# Environmental Impact Report for the Palms Groundwater Recovery Project

State Clearinghouse Number 2020060315

**Buena Vista Water  
Storage District**

Prepared by:  
**GEI Consultants, Inc.**

**Figure 2-2. Recovery Project Location**

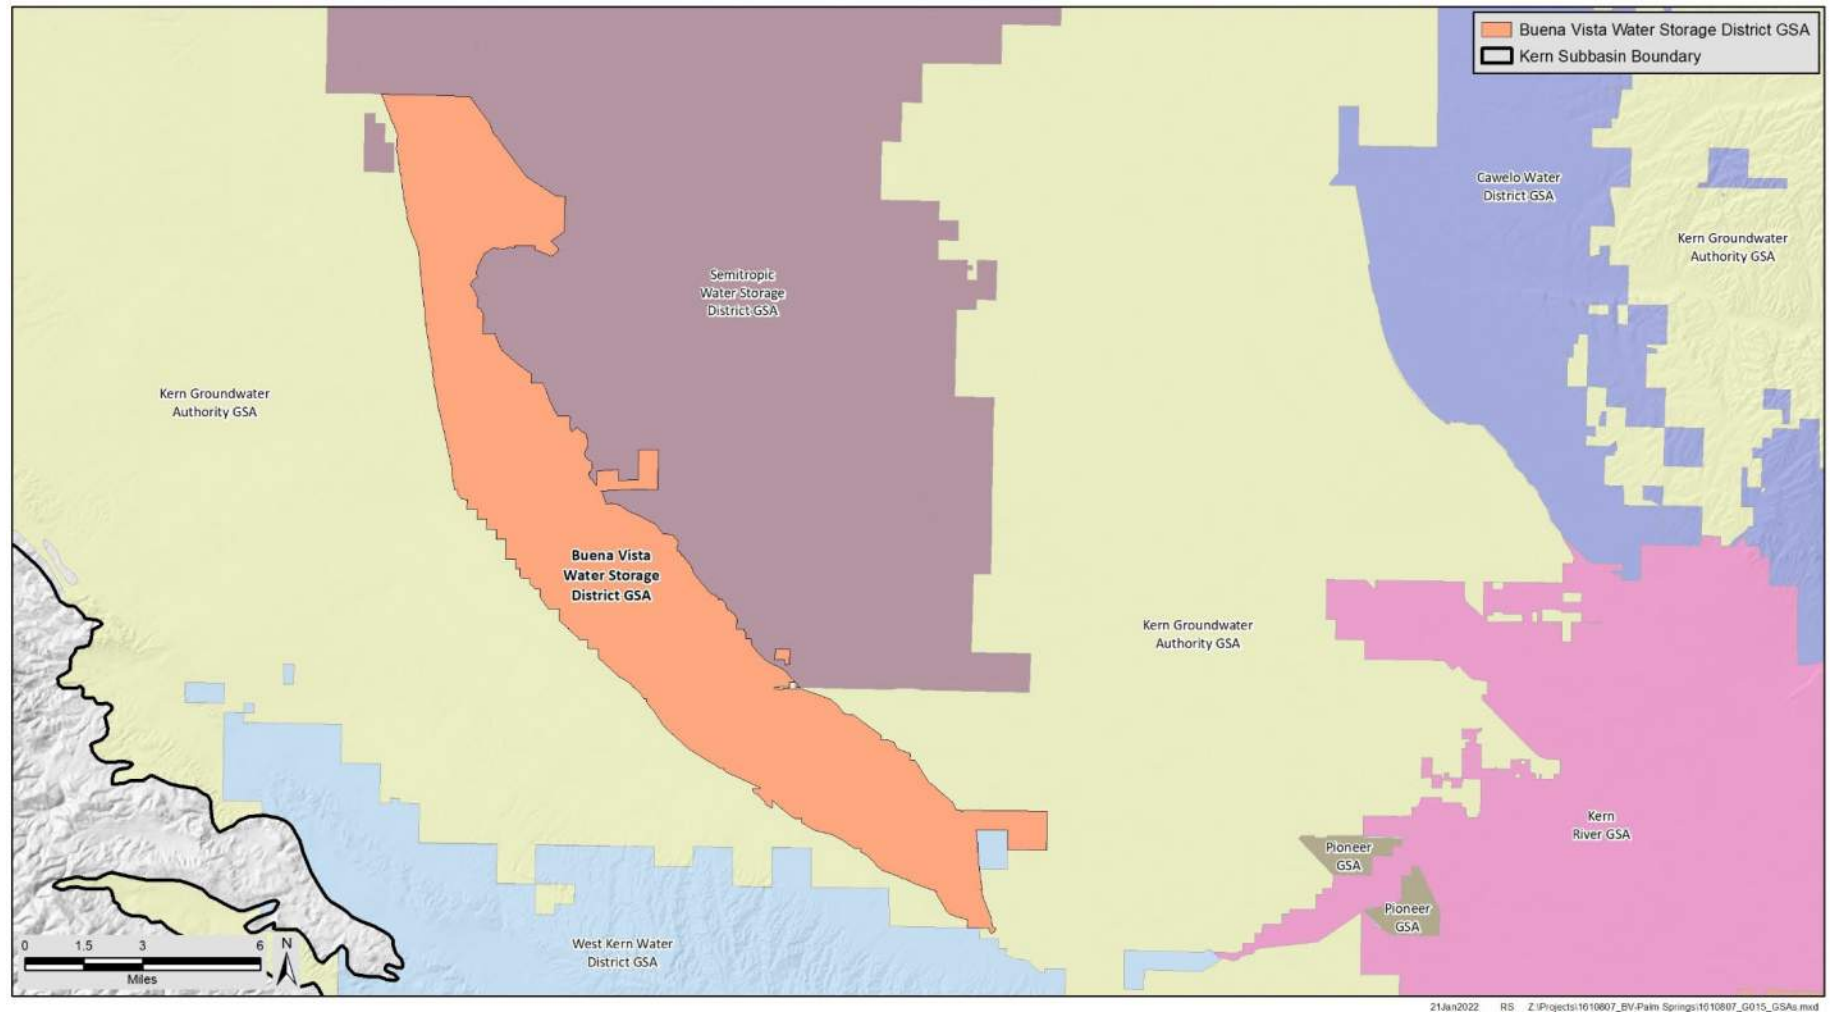
**KCWA-7:** *Based on Figure 2-2, the Project recovery facilities are located up fan of the Palms Groundwater Banking Project facilities, however, it is common knowledge that all banked water is recovered down fan from the recharge area. The DEIR indicates that Buena Vista will join the Kern Water Bank Authority Joint Operating Committee (JOC) or amend or enter into a new MOU. Should Buena Vista be permitted to join the JOC, it will still be required to enter into a new MOU that demonstrates the Project is in the spirit of the KFMC MOU. While the KFMC MOU allows for recovery of banked water outside of the project site, it requires consent of both the KFMC and the district or entity with jurisdiction over the recovery area. Therefore, the DEIR should be amended to include discussion of the KFMC MOU's provisions and how the Project will meet those requirements.*

***KWBA-6:** Neither the text nor Figure 2-2 identify the District boundary or the locations of the BVGSA, the WKWD Banking project or GSA, the Kern Water Bank, or the KGAGSA. All of these facilities/agencies are directly adjacent to the Project and significant stakeholders in the groundwater basin where that portion of the recovery project outside the District is located.*

**Response:** The recovery facilities shown on Figure 2-2 of the DEIR are distributed between facilities up fan of the recharge facilities and facilities located down fan within the recharge area. The recovery facilities located up fan of the recharge areas are separated from the recovery facilities because this area is not well-suited to groundwater recharge. As described in Master Response #7- Regional Groundwater Level Contour Mapping and Flow Analysis, groundwater flow direction is generally to the southeast in this area. meaning groundwater recharged at the Palms flows towards the eastern recovery wells. Thus, the distribution of recharge and recovery facilities is designed to achieve the project purpose by placing the recharge facilities in the area best suited for recharge while recovery facilities are located to produce a water supply that will minimize requirements for treating recovered water and to spread the recovery operations over an area sufficiently broad to minimize well interference, breaches of MTs and other impacts of concentrated pumping.

**Response:** Figure 2-3 has been added to this FEIR to depict the District boundaries and boundaries of GSAs in the area. Figure 3-9 of the DEIR displays the location of banking operations, operated by others, in the area of the Recovery Project. See also Master Response #7 - Regional Groundwater Level Contour Mapping and Flow Analysis, which provides maps of the neighboring GSAs.

Figure 3-7. Groundwater Elevation Map of the Buena Vista Water Storage District

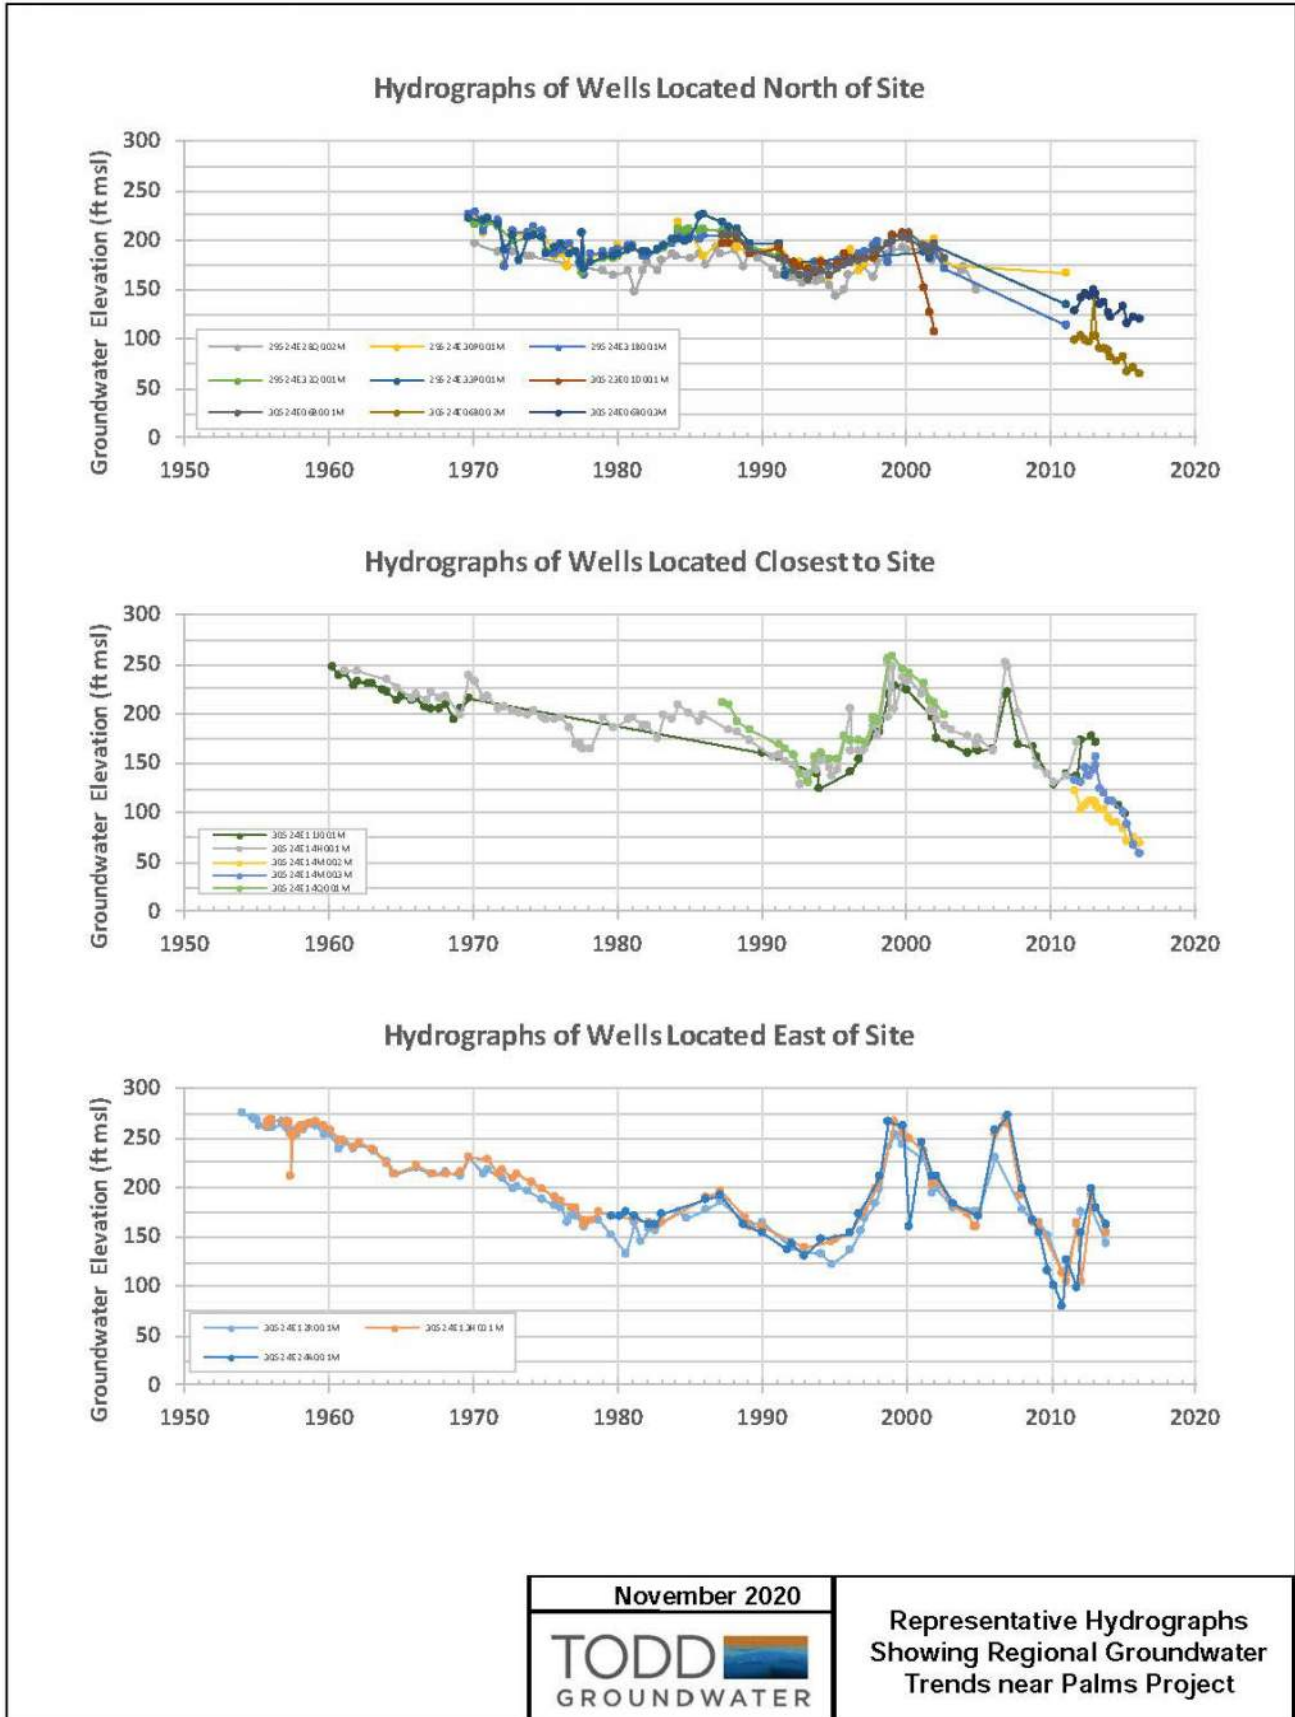
- 8 8. The general groundwater flow direction shown on Figure 3-7 of the DEIR appears to be a reasonable interpretation based on regional data. Closer to the proposed project however, in the southern portion of the BVSWD service area, groundwater flow directions are reported to vary in response to recharge and recovery operations by WKWD, the Kern Water Bank, and other factors. Were variable groundwater flow directions considered as part of the analyses? Would groundwater flow directions other than northwest to southeast result in significantly different simulation outcomes?

**Figure 3-15. Groundwater Level Change at Recovery Wells, 100% Recovery of Recharged Water (Scenario A)**

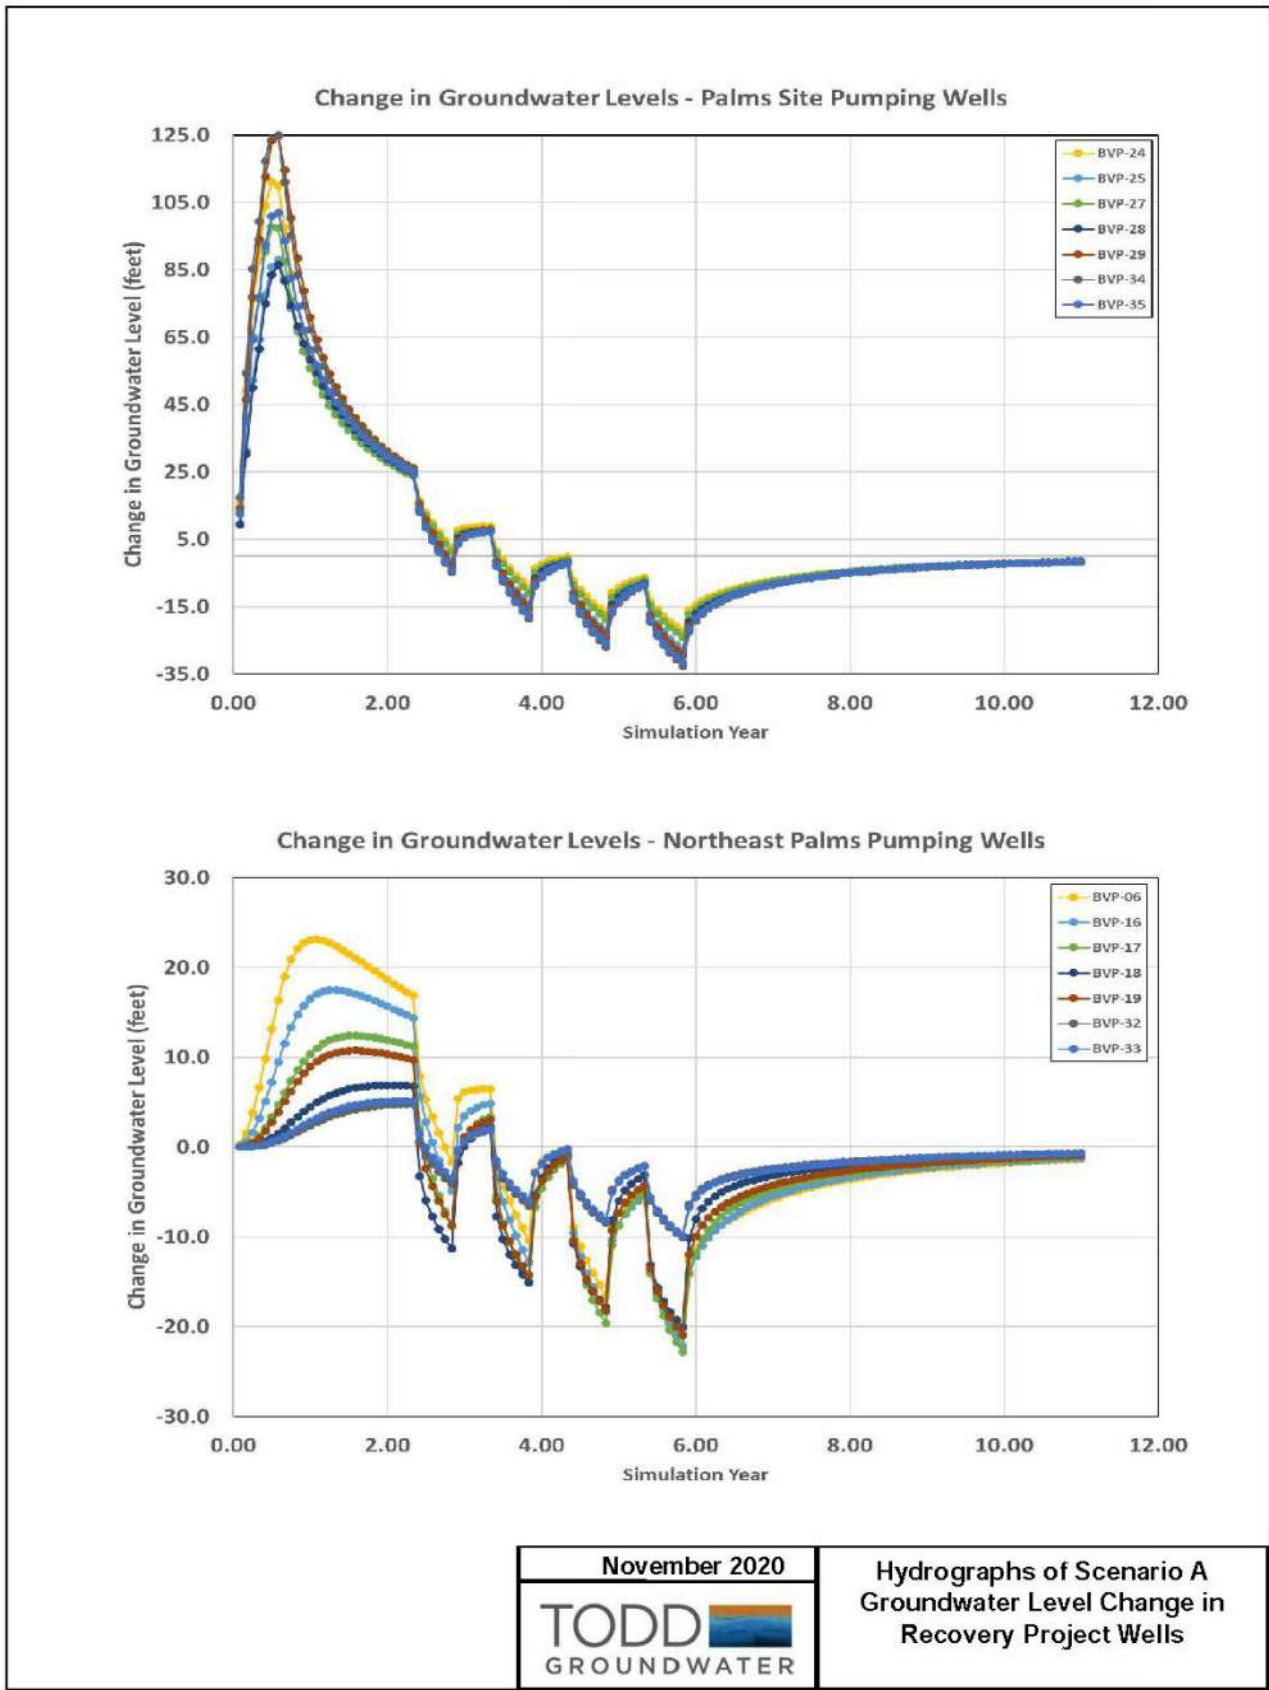
**WKWD-3:** *On Figure 3-15, the simulated monitoring point named MW\_WKWD shows the change in water level at the end of year 6 reaches -15 ft. Would this be considered a significant impact?*
